PERMIT MODIFICATION APPROVAL

Re: Permit Modification Approval for API Number 9502280, Well #: 512892

Adjust FW and INT. Casing

Re: Modification of 095-02278, 02279, 02280, 02281

Well 512892(WEU4H3)
EQT Production
West Union
Tyler West Virgina

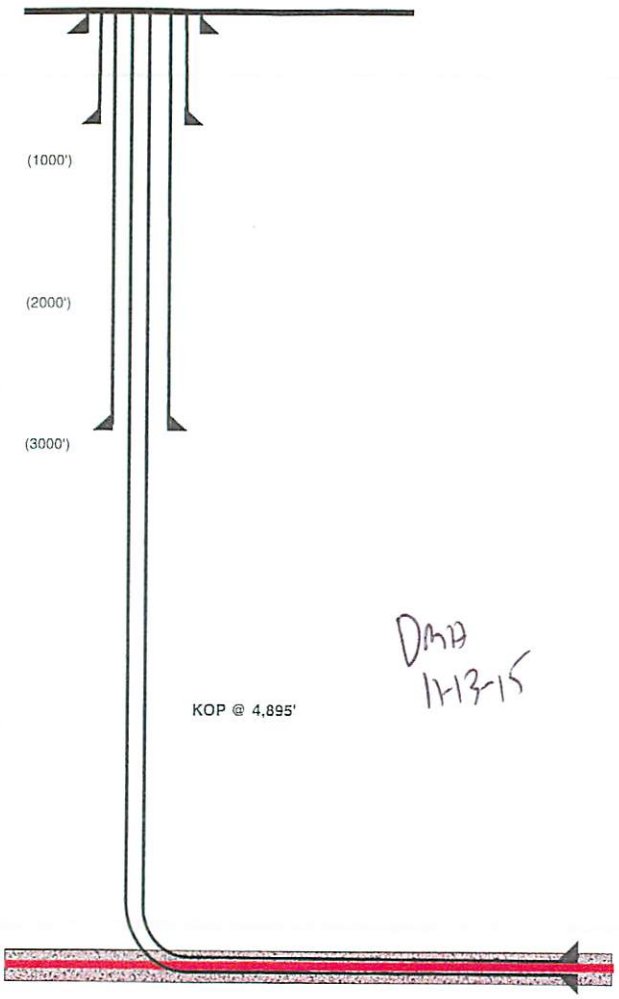
EQT is requesting the 13 3/8" surface casing to be set at 750' KB, 50' below the coal at 696-700' KB. We will set the 9-5/8" intermediate string at 2865' KB, 50' below the base of the Gordon.

Hole Size (inches)	Casing Type	Size (inches)	Wt (ppf)/Grade
24	Conductor	20	81#/MC-50
17 1/2	Surface	13 3/8	54.5#/J-55
12 3/8	Intermediate	9 5/8	40#/A-500
8 1/2	Production Casing	5 1/2	20#/P-110
